SERVICE BULLETIN

TR-7800, TR-7850

#860

SUBJECT: Memory Channel 7 Indicator Erratic

▼ CONTROL UNIT (X53-1180-XX) XX: 10(K), 61(W)(T)

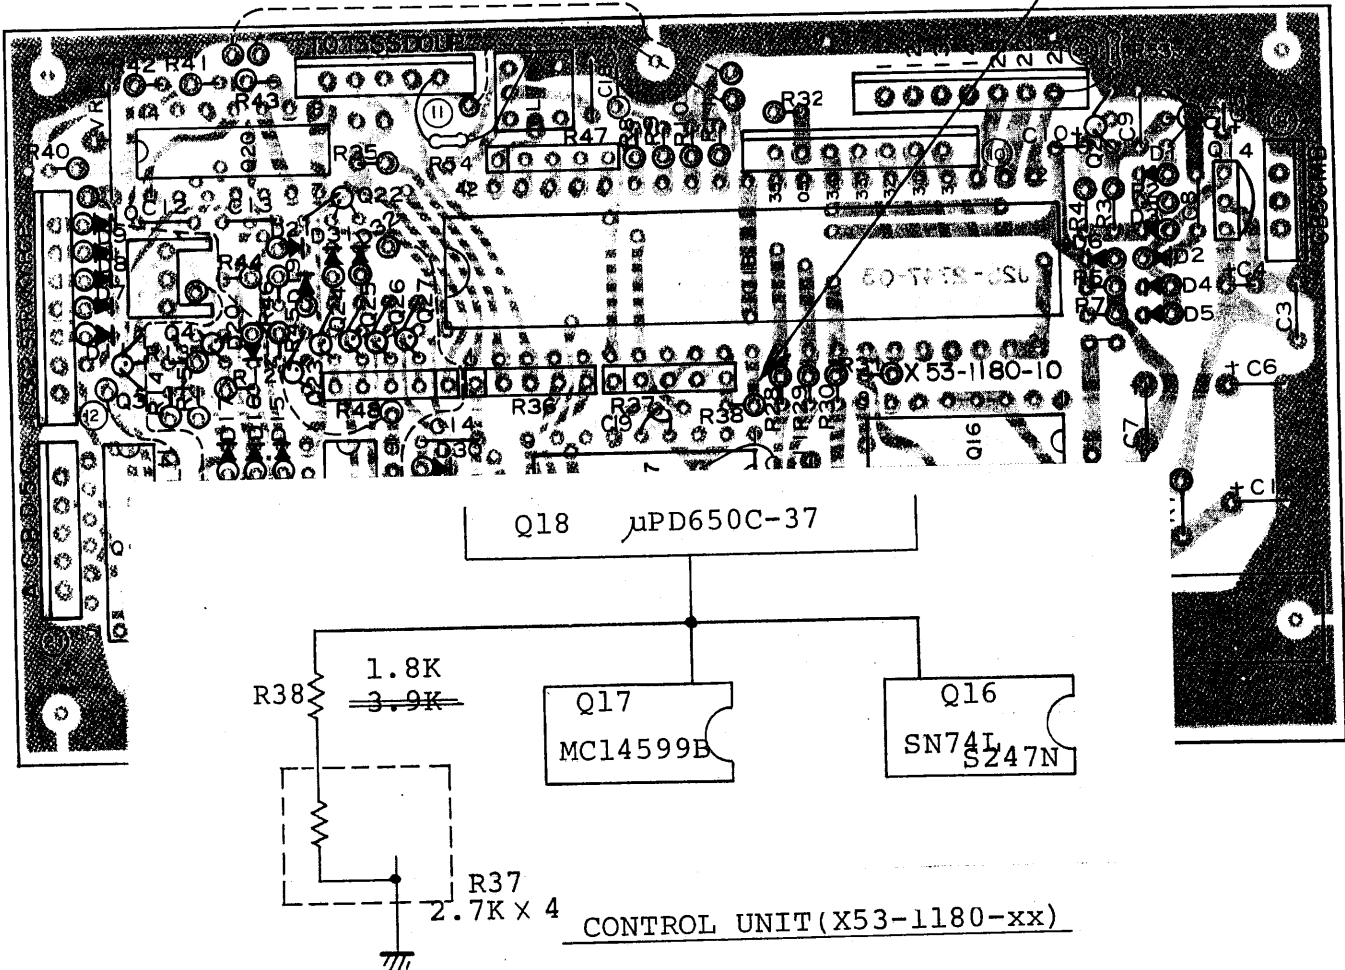
When Memory Channel 7 is selected, the LED may fail to indicate the number 7, although frequency is correctly recalled and all other operations are normal. Cause is incorrect voltage level at Q16 & Q17, and is related to individual differences between these IC's. Correction is by changing one resistor value on the Control unit.

~~3.9K~~ → 1.8K

On the Control unit X53-1180-xx, replace R38 from 3.9k Ω to a 1.8k Ω resistor (RD14CB2E182J). No adjustments are required.
